June 20, 1996

On Thursday May 30, 1996 we conducted an inspection of the Atlas mine site. The purpose of this inspection was to evaluate remedial activities recently completed by the responsible party (RP), determine if additional improvements are necessary, and identify areas of the site that could be revegetated. Participants were:

SKETCH OF ATLAS SITE
DRAINAGE IMPROVEMENTS
OBSERVATIONS FROM
5/30/96 INSPECTION

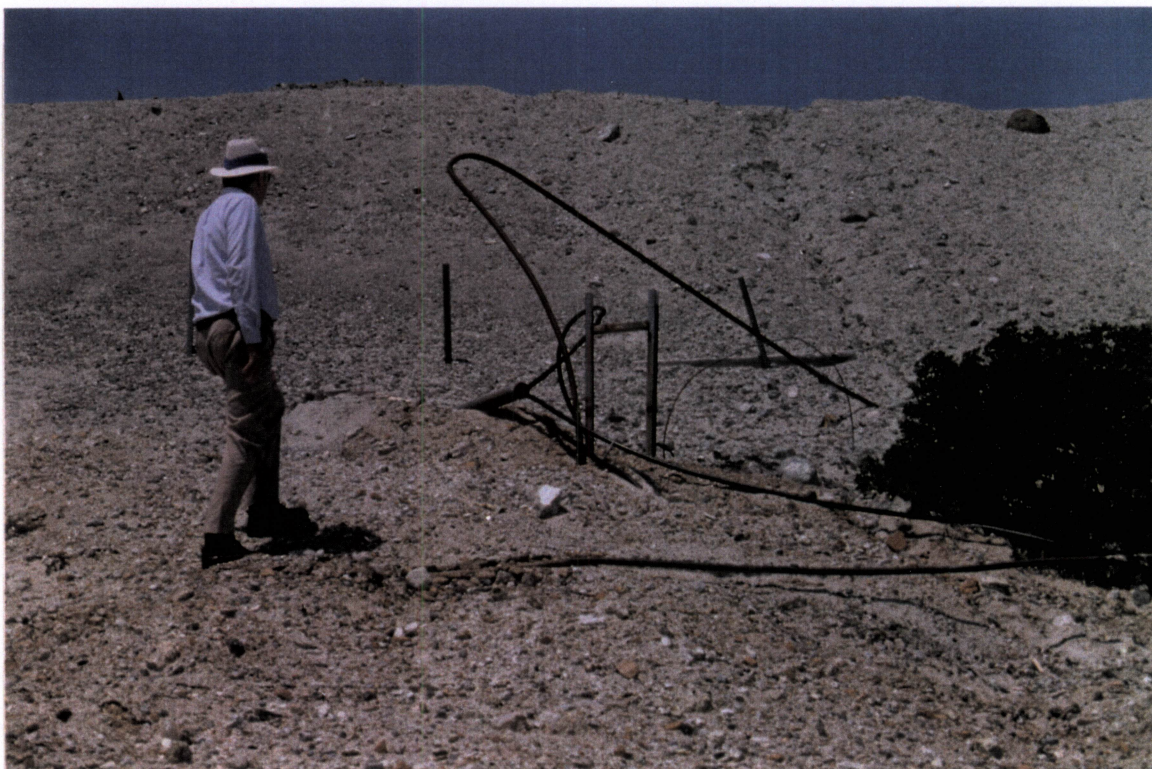
- c) Road drainage - Road drainage has been improved on both sides of the chip sealed road near the entrance to the mill area (see attached sketch). The RP will need to cut a ditch from the upper mine road to induce runoff into the drainage ditch west of the chip sealed road (see photograph 1). Drain rock placed where the drainage ditch west of the chip sealed road crosses the access road to Pond B should be redistributed allowing flow across the access road (see photographs 3 and 4). The diversion berm

NOTE: FENCE EXTENSIONS WILL BE
ADDED TO EAST AND WEST SIDES OF THE
UPPER GATE

NOTE: RUNOFF FROM
UPPER MINE ROAD WILL
BE DIVERTED INTO DITCH

NOTE: DITCH WAS EXTENDED
TO POND E

MILL DEBRIS
TO BE
REMOVED

(3)

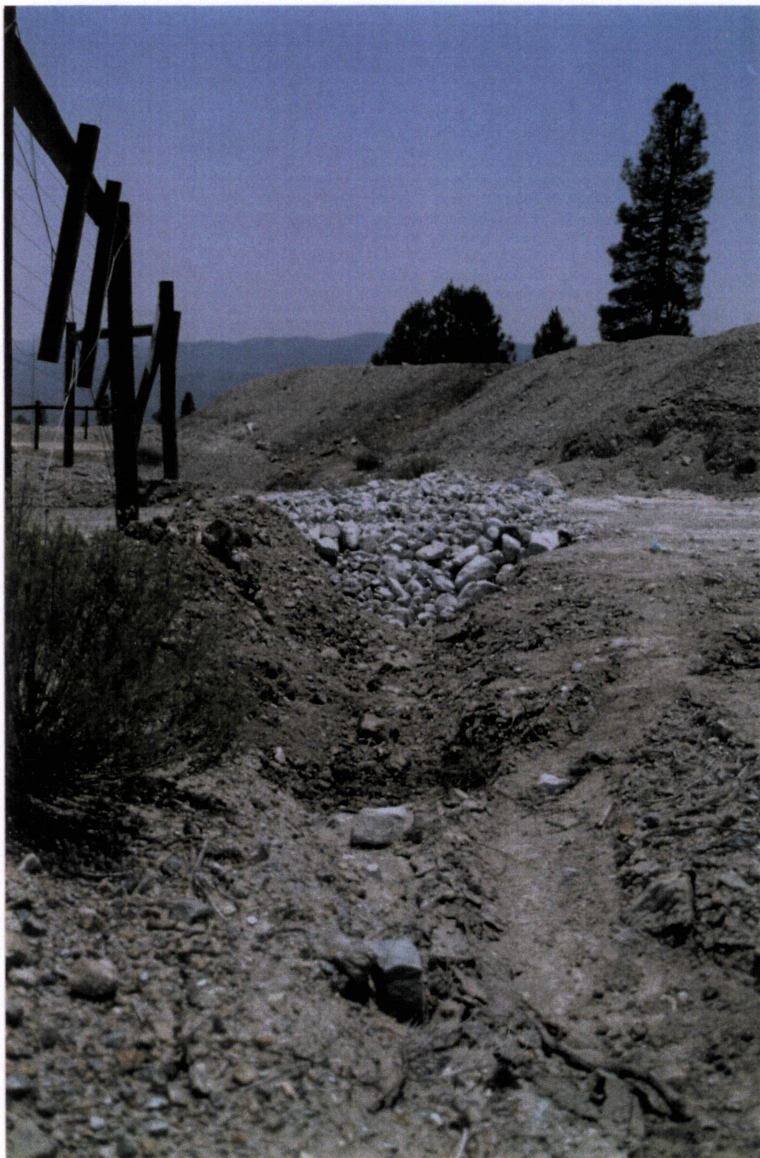
Side view of the road to
Pond B at the drainage ditch
west of the BLM fence. The
rock looks like it will prevent
runoff from flowing through the
drainage ditch.
